Service Bulletin 4812 712 40387

TITLE: LID does not stay in open position on HR (High Range)models.

SUBJECT: In some circumstances can it happen, that the door lid does not stay in open position.

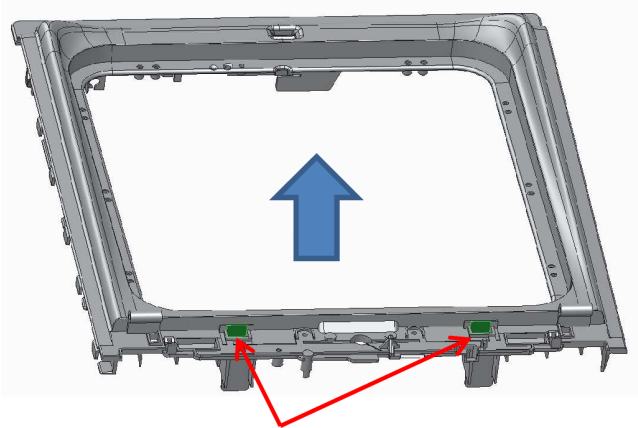
Root cause: Torsion rod (Spring) is touching surface on Top frame when opened, which causes to don't stay in open position!

Torsion rod (Spring) is touching surface
on Top frame when opened.

It is required to adjust (cut &/or grind) away material on pointed surfaces towards to the front (not rear!).

Current status – Top Frame

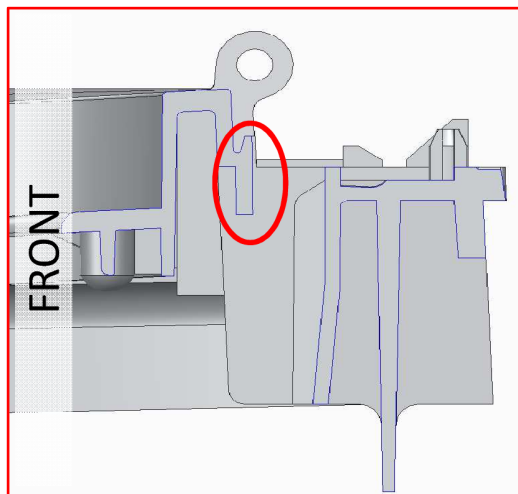
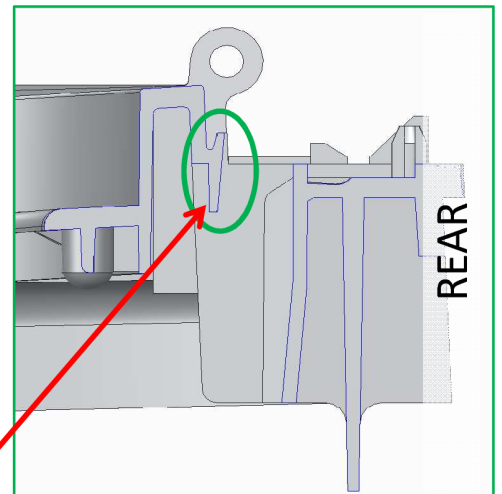
After adjustment

Grind out material in area pointed by arrow

Step 1.
Remove the hinge bolts & pull up the Lid.

Step 2.
Grind out 2-3 mm of the plastic by a rasp (as shown in the picture)

Be careful to don't damage the bellow with the rasp!

**(!) Attention: Do not grind rear surface.
This area is supporting springs to keep the door opened!!!**
